UNITED STATES PATENT AND TRADEMARK OFFICE

APPLICATION NO.	FILING DATE	FIRST NAMED INVENTOR	ATTORNEY DOCKET NO.	CONFIRMATION NO.
10/712,286	11/12/2003	Robert J. Mills	14649	9293

Office Action Summary

DETAILED ACTION

Barecki ('182) Fig. 3

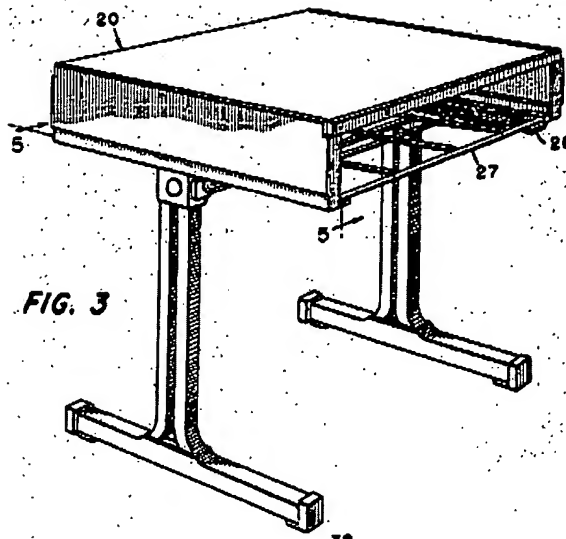
11. Claims 9-16 are rejected under 35 U.S.C. 103(a) as being unpatentable over US Patent 3,758,182 to Barecki in view of US Patent 2,535,743 to Lundahl and US Patent 6,056,178 to Rapp-Duncan. . Barecki ('182) teaches in Fig. 3, a desk (20) with a top (21) and a support structure (24). The desk (20) is bottomless with support runners (26) that define the front opening. The runners (26) support a bottom rack (27), which is made of wire mesh and has many openings. In figures 6 and 7 Barecki teaches a pencil case (28) that could replace the bottom rack (27) on the desk and thus is teaching a desire to have a pencil case in that location.

12. Barecki ('182) does not disclose expressly a pencil case attached with a pencil case attachment plate to the bookrack, a portion of the pencil case being disposed below the bottom wall of the book rack, and the pencil case with a bottom wall, a pair of opposed side walls, a front wall and a rear wall.

Lundahl '743 Figure 1

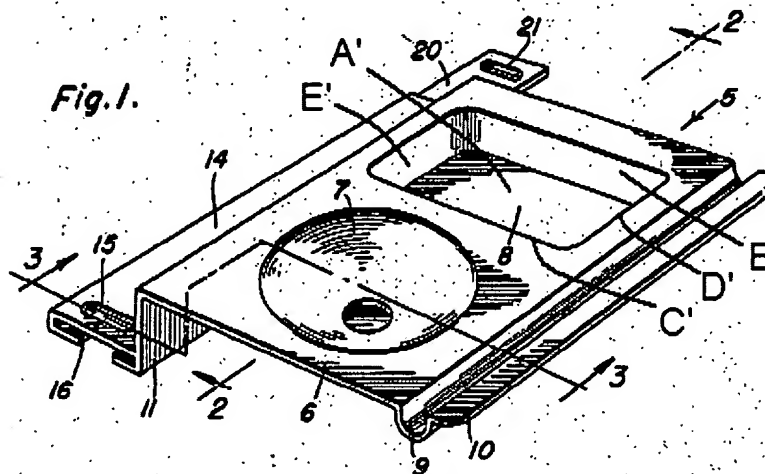
13. Lundahl teaches a pencil case (5) that has a portion (14) that is below the bottom of the typewriter (13) and the portion (14) is considered a bottom wall of the pencil case (5). The pencil case (5) has a first section (8) with a bottom wall (A'), opposing side walls (B', C'), a front wall (D'), and a rear wall (E'). The first section (8) is sized to retain a ruler or protractor within the walls. Rulers and protractors come in many sizes including some that are relatively small. Also note; a change in size is generally recognized as being within the level of ordinary skill in the art. *In re Rose*, 105 USPQ 237 (CCPA 1955). The pencil case is comprised of an upper compartment/ first section

(8) and a lower compartment/second section (7). The lower compartment (7) is disposed next to or outside the typewriter (13). The second section (7) has a bottom wall and walls in the shape of circle and the circular wall is considered to be made of a front wall, a rear wall, and opposing side walls integral formed together. A third section (9) is higher than the first section and has a bottom wall, front wall, and a rear wall.

16. Regarding claims 11, and 14, at the time of the invention it would have been obvious for a person of ordinary skill in the art to modify the book rack and pencil case of Barecki in view of Lundahl and Rapp-Duncan by removing the flange (11) on the pencil case (5) since the purpose of the flange (11) was to raise the compartments off of the tabletop and in the current location this is not needed and it would be cheaper and easier to manufacture with out the flange (Lundahl '743, Col. 2, lines 9-13). This would

Rapp-Duncan '178 Figure 1

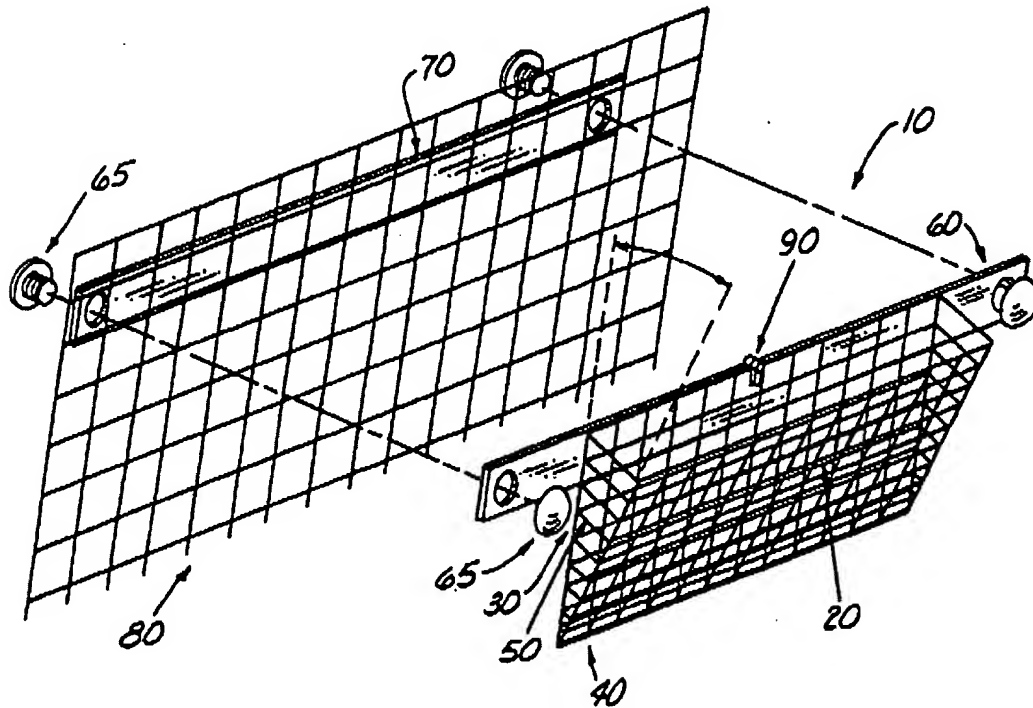
14. Rapp-Duncan teaches an auxiliary bin for a shopping cart. The shopping cart (80) is made form wire mesh. The bin (10) is made form a smaller wire mesh and is attached to a bar (60). The wire mesh shopping cart (80) is sandwiched between a attachment plate (70) and the bar (60) on the bin (10).

15. At the time of the invention it would have been obvious for a person of ordinary skill in the art to modify the desk and book rack of Barecki by adding the pencil case as taught by Lundahl in the manner as taught by Rapp-Duncan since the pencil case would

allow items such as pencils to be kept near the desk (Lundahl '743, col. 1, lines 7-20)
and the attachment would be simple (Rapp-Duncan '178, Col. 2, lines 31-33).
